RE: Project No. 12611-003 – New York, Roosevelt Island Tidal Energy Project
Request for Additional Information on Draft Pilot License Application

ROOSEVELT ISLAND TIDAL ENERGY PROJECT
P-12611-003

**VERDANT POWER RESPONSE TO
REQUEST FOR ADDITIONAL INFORMATION ON
DRAFT PILOT LICENSE APPLICATION**

Figure 5.3.3.2-1 RITE Hydroacoustics: June 2007-December 2008 – all targets

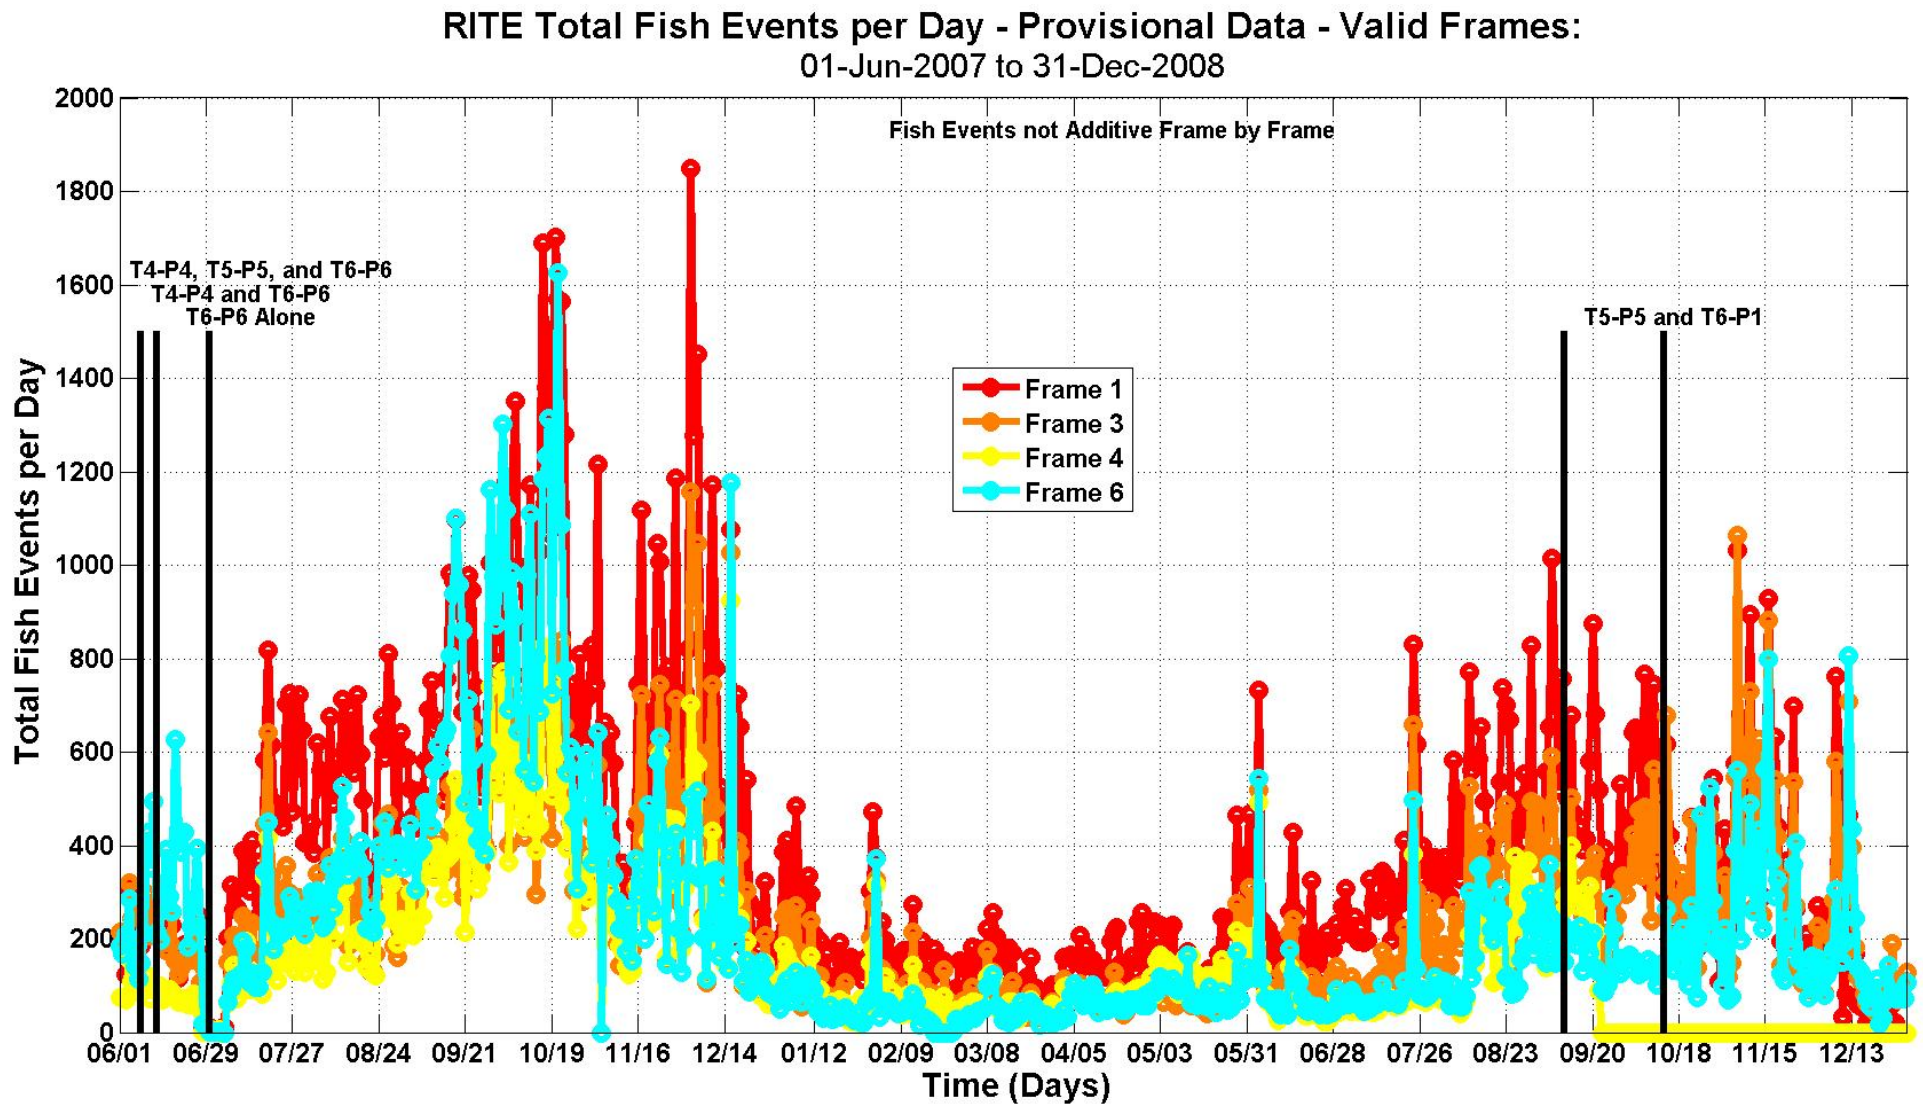
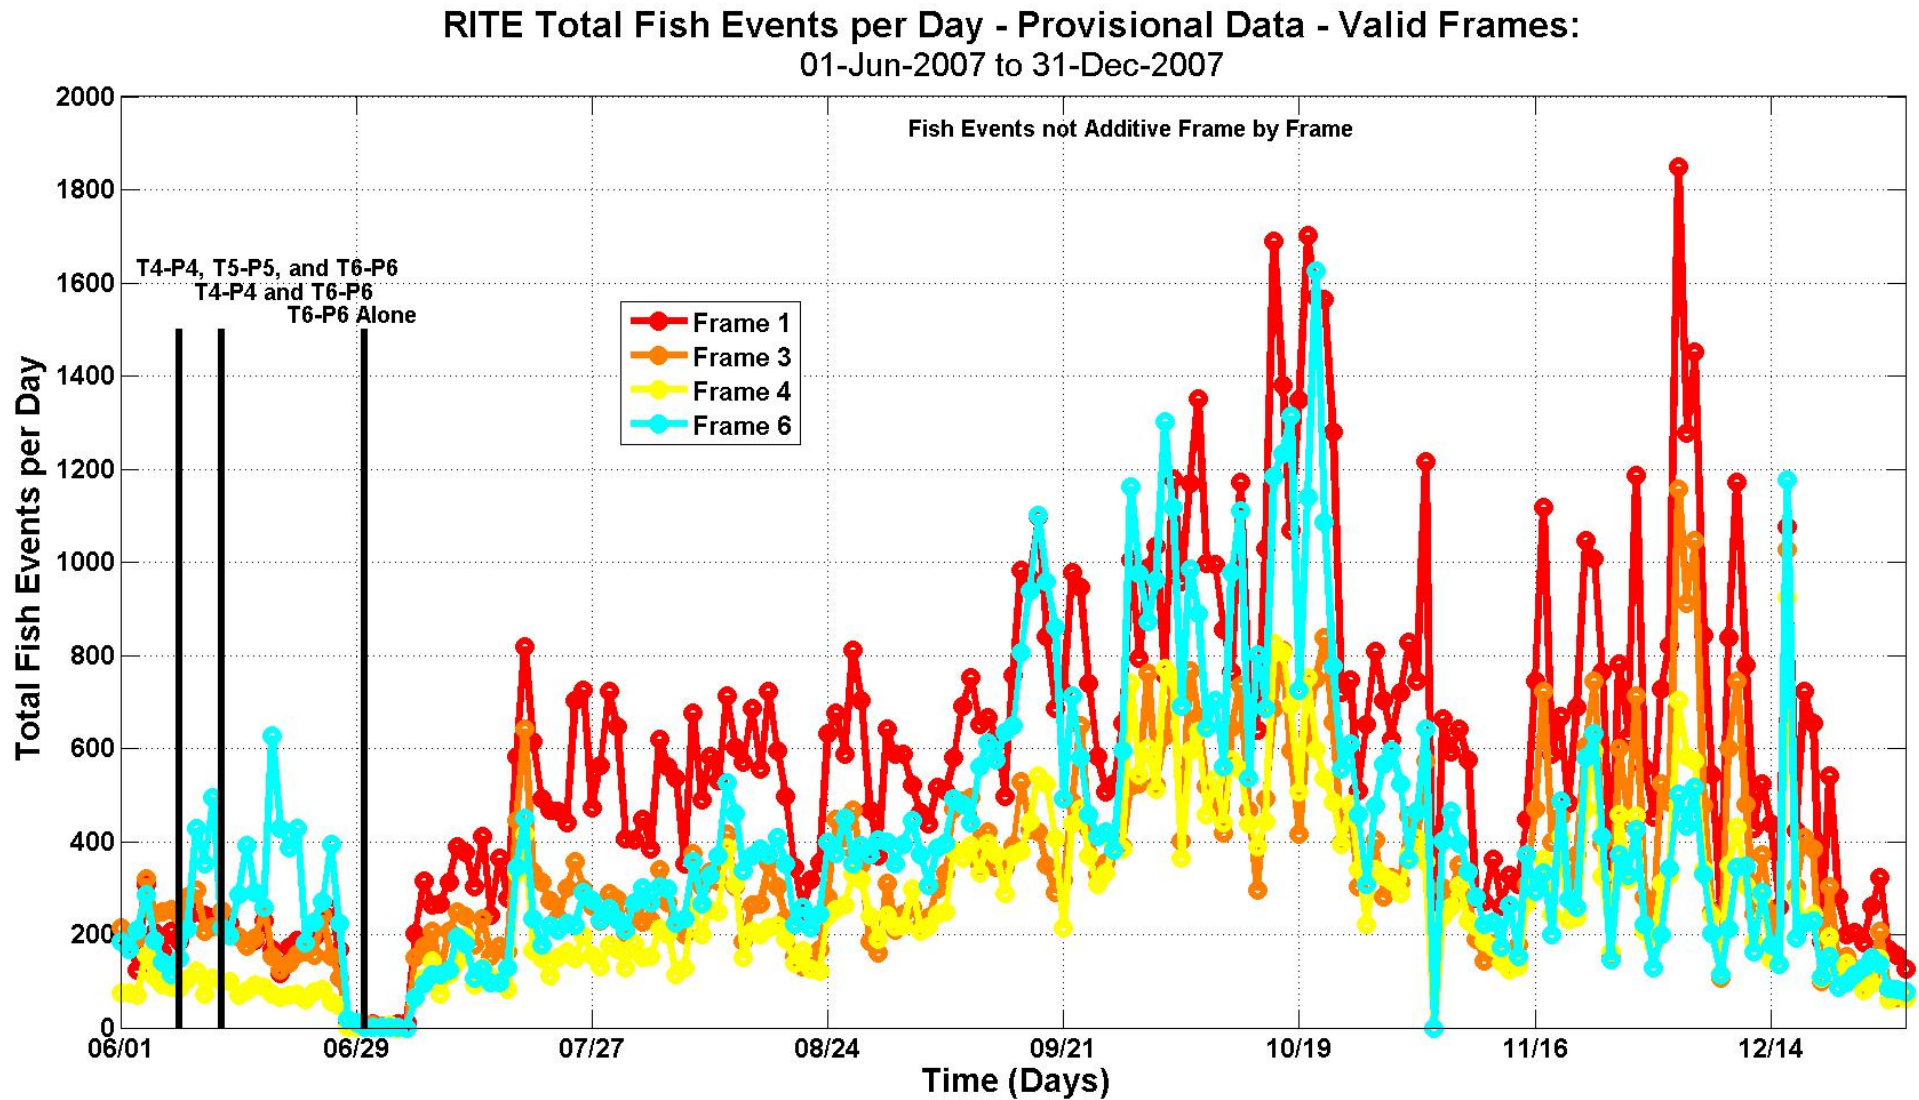
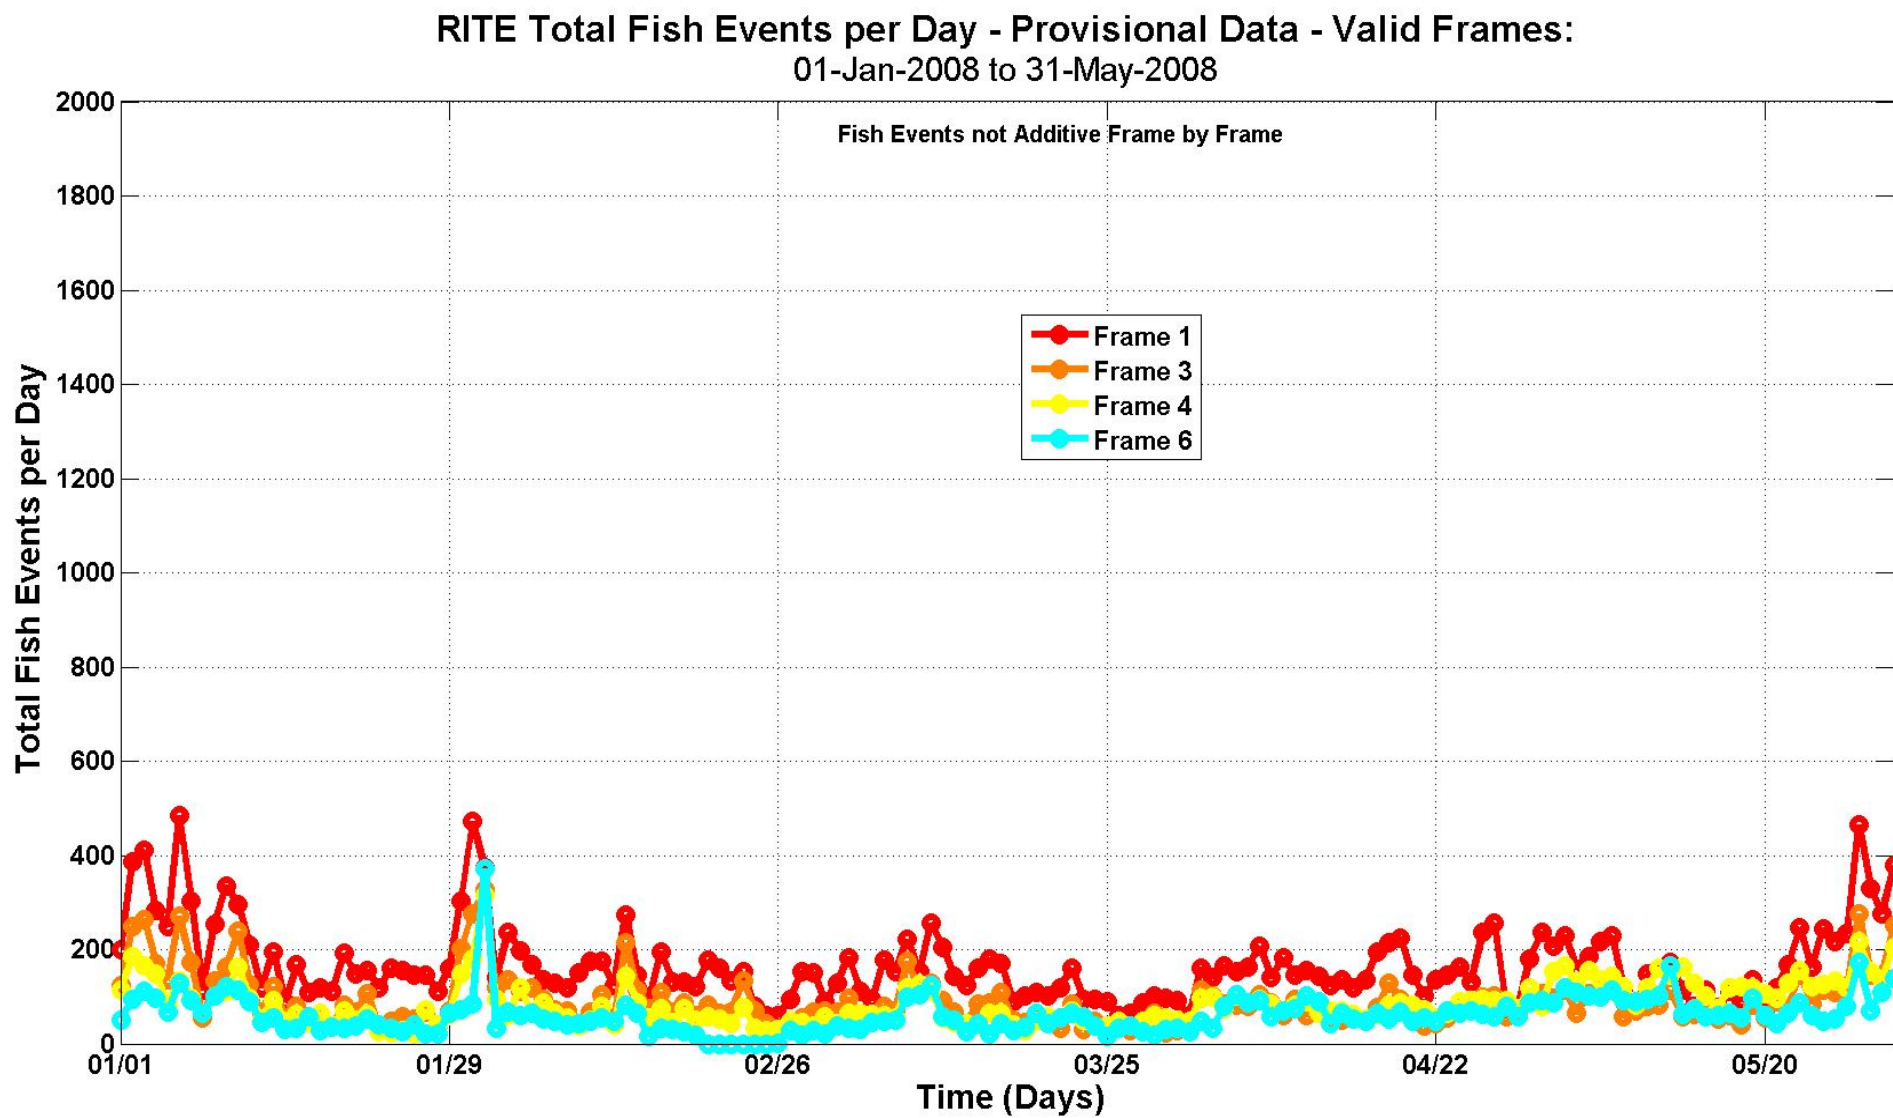
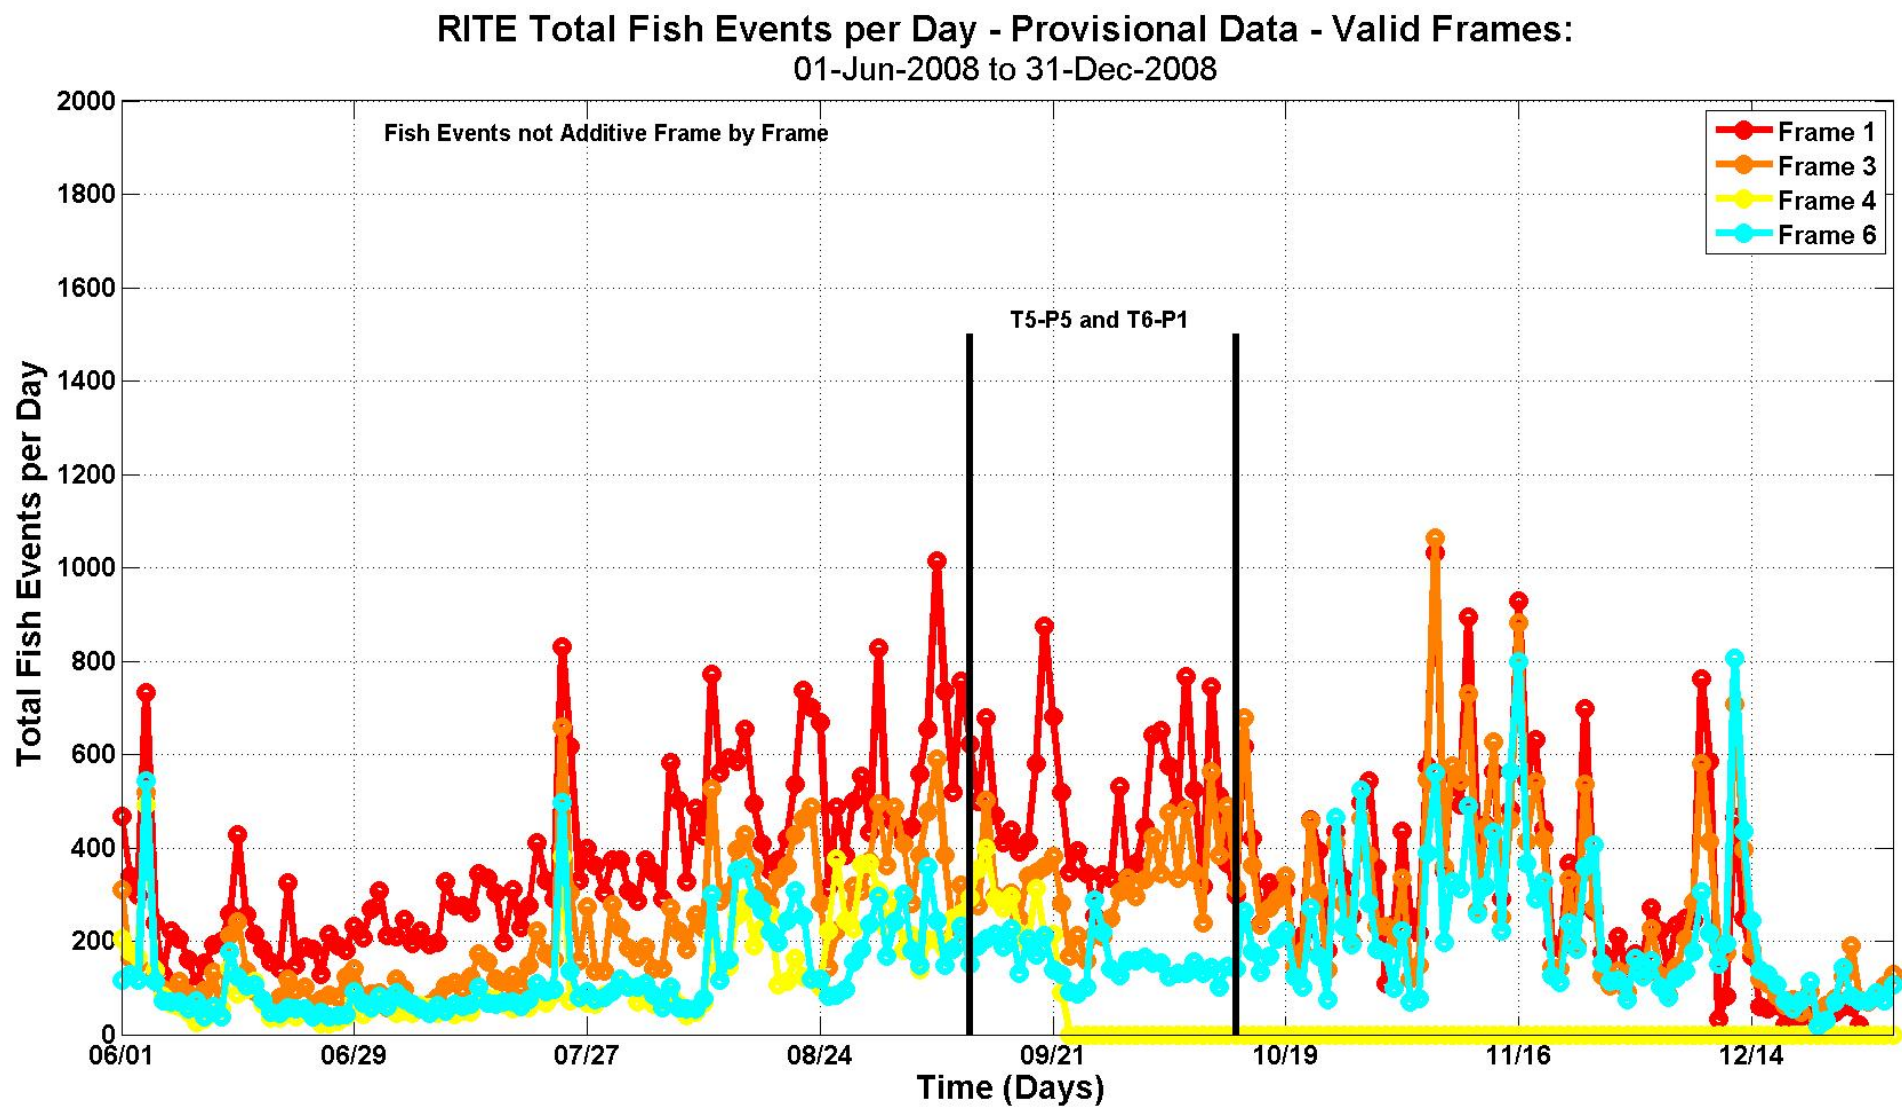
9(d). Page E-102, figure 5.3.3.2-1 shows daily fish events recorded in the hydroacoustic study. In order to more easily differentiate between the frames and event readings and adequately interpret the monthly/seasonal patterns, please provide a larger version of the graph, possibly even splitting the 2007 and 2008 results into two different figures.

Provided below are the modifications to the figure as requested – including an increase in font size, font weight, and overall figure size. Further, the data has been extended to include the completion of 2008. As such, the data is plotted from 6/1/07 to 12/31/08.

- 1) Revised Figure 5.3.3.2-1 RITE Hydroacoustics: June 2007 – December 2008 – all targets.
- 2) Figure 5.3.3.2-a RITE Hydroacoustics 2007: 6/1/07 to 12/31/07
- 3) Figure 5.3.3.2-b RITE Hydroacoustics 2008: 1/1/08 to 5/31/08
- 4) Figure 5.3.3.2-c RITE Hydroacoustics 2008 6/1/08 to 12/31/08

Figure 5.3.7.1-1. Navigation zones near the RITE Project

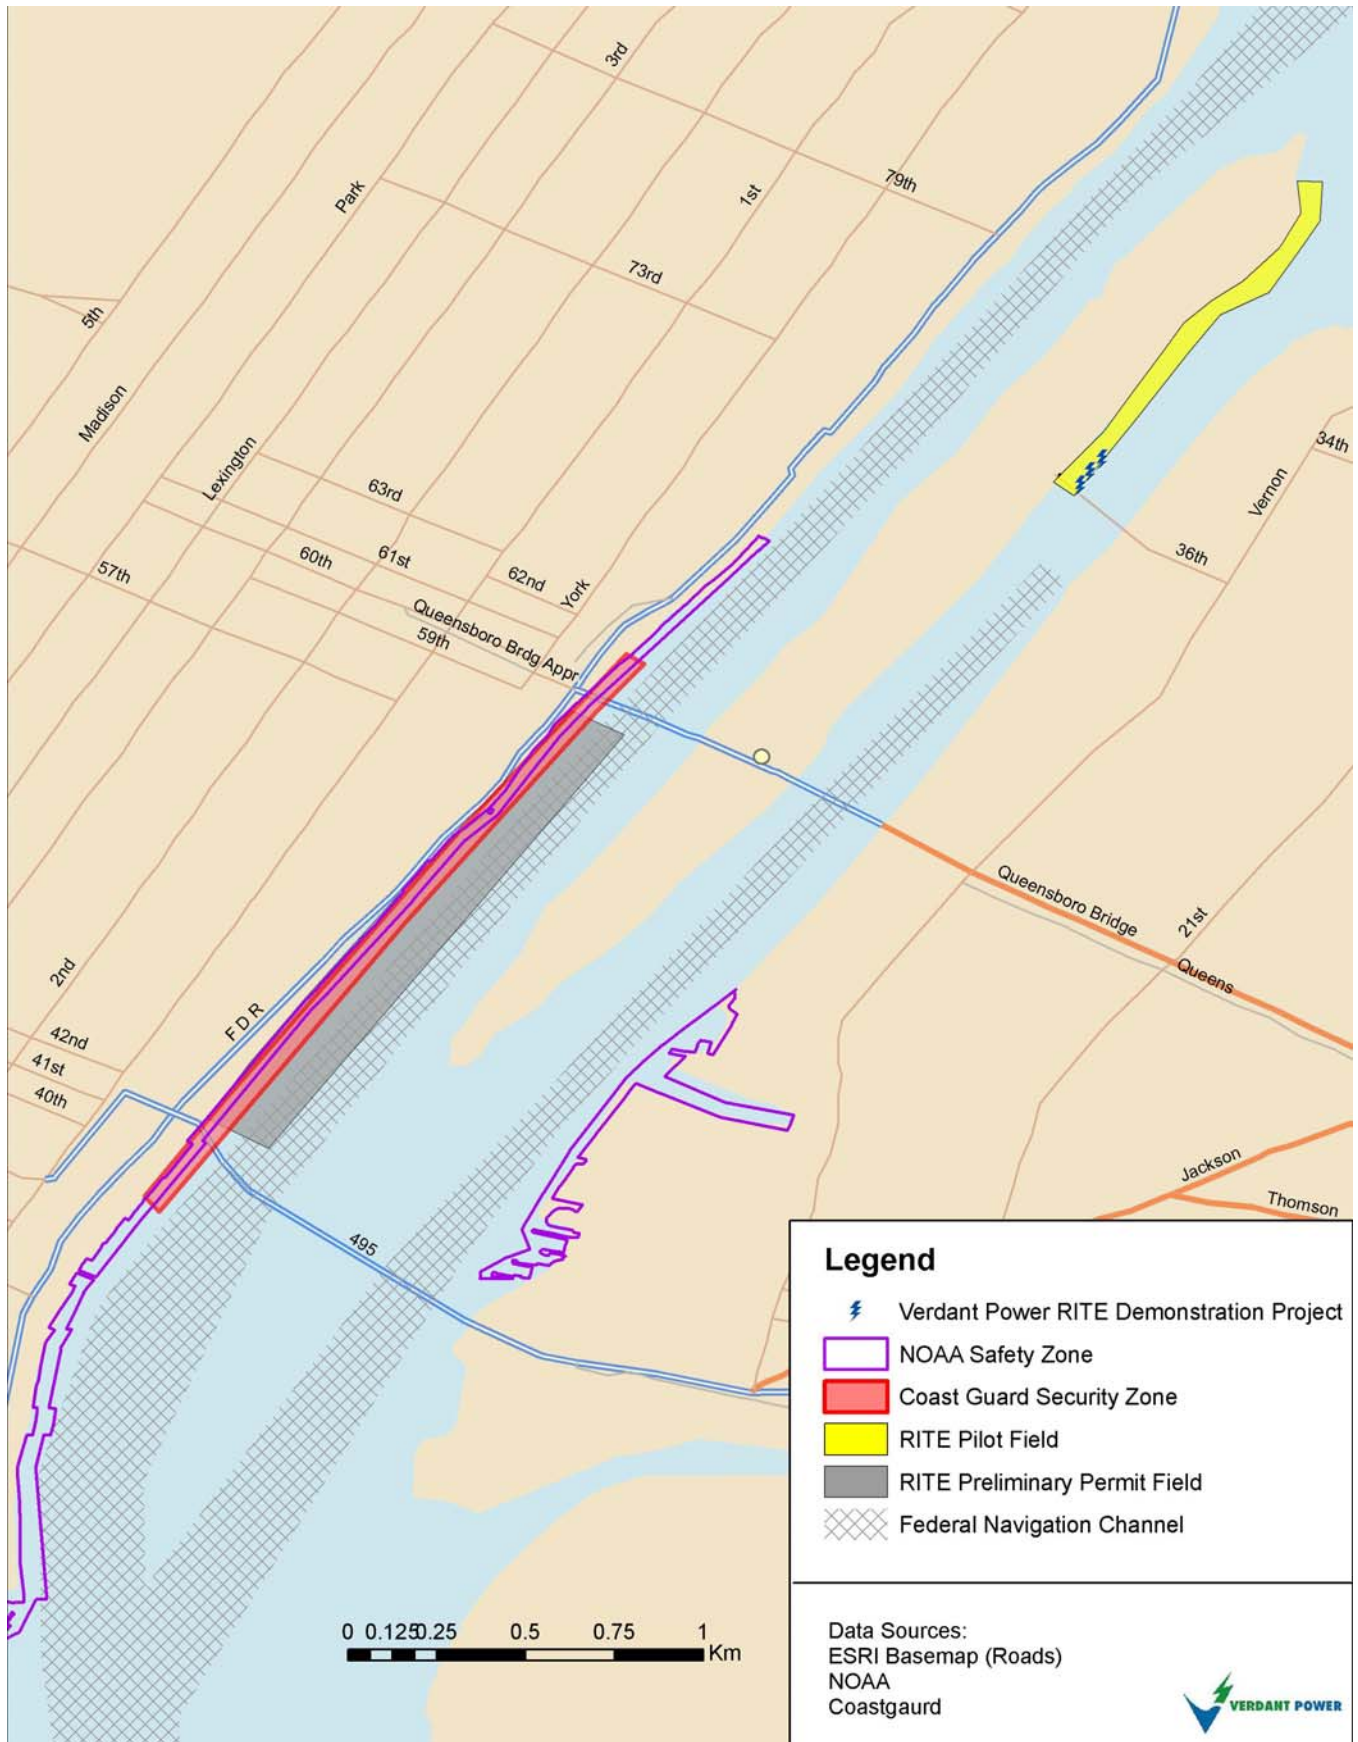
12(a). Page E-169 states that the west channel of the East River is a commercial navigation channel and the passage along the channel known as Hell Gate is designated as the federal navigation channel. In figure 5.3.7.1-1 on page E-171, it appears that the area within the Coastguard Security Zone is labeled (shaded in white) as a federal navigation channel. Please clarify, within the text and clearly depicted on page E-171 (figure) where the federal navigation channel is located.

Verdant acknowledges that Figure 5.3.7.1 -1 on page E-171 reproduced poorly on both the electronic and printed version. We apologize for the confusion. We have revised the figure to more clearly indicate:

Verdant's project boundary for the Preliminary Permit for the West Channel field (Gray shading) does encroach on the Federal navigation Channel. We have made it clear in discussions with the US Coast Guard and the Harbor Operations committee that the preliminary permit boundary is necessarily larger for environmental and resource assessment study purposes than a planned Verdant engineered tidal energy project. These discussions are ongoing. The revised version of the map can be found in Appendix B.
